Simons Architecture
Joe Simons,
P.O. Box 67408
Albuquerque, NM **87113**

Mojgan Maadandar, E.I.
Associate Engineer, Planning Dept.
Development Review Services

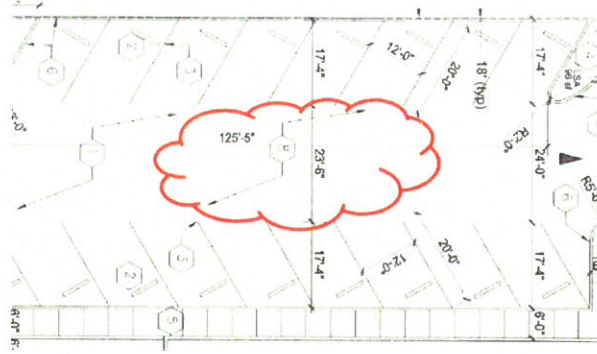
1. The minimum lane width should be 12'. In the pay station area, the 8' width seems very narrow.
2. The handicap accessible spaces must include an access aisle. Van accessible aisles should be 8ft wide; all others should be 5ft wide.
3. The ADA access aisles shall have the words "**NO PARKING**" in capital letters, each of which shall be at least one foot high and at least two inches wide, placed at the rear of the parking space so as to be close to where an adjacent vehicle's rear tire would be placed. (66-1-4.1.B NMSA 1978)
4. Please justify the sign location (number 14) as shown in the picture.

5. Please justify number 8 as shown in the picture. It seems that it should be typo.
